VIRGINIA ELECTRIC AND POWER COMPANY (DOMINION)
NORTH ANNA POWER STATION UNITS 1 AND 2
PROPOSED IMPROVED TECHNICAL SPECIFICATIONS
REQUEST FOR ADDITIONAL INFORMATION (RAI)
SECTION 3.8 (TAC Nos. MB0799 and MB0800)

Proposed Improved Technical Specifications Responses to Requests for Additional Information ITS 3.8, "Electrical Power Systems"

North Anna Power Station Units 1 and 2

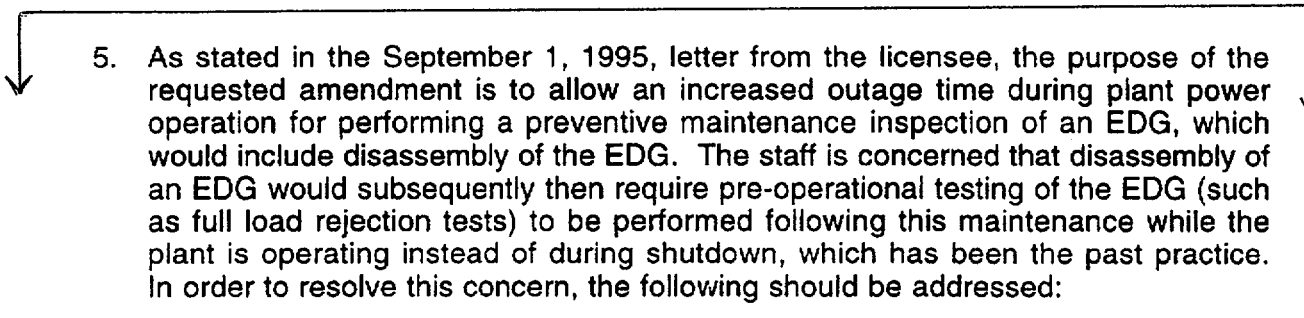
3. On Pages 1-3 of the proposed Technical Specifications for Unit 2, the word "emergency" has been added to the last sentence of Definition 1.12. This change is also applicable to Unit 1 but has apparently not been included in the amendment request. Is this change also requested?

Yes, this change is also requested. The revised Technical Specification page is attached. This change is discussed in general in the Specific Changes Section of our Proposed Technical Specification Change on Page 5 of 10 of Attachment 1.
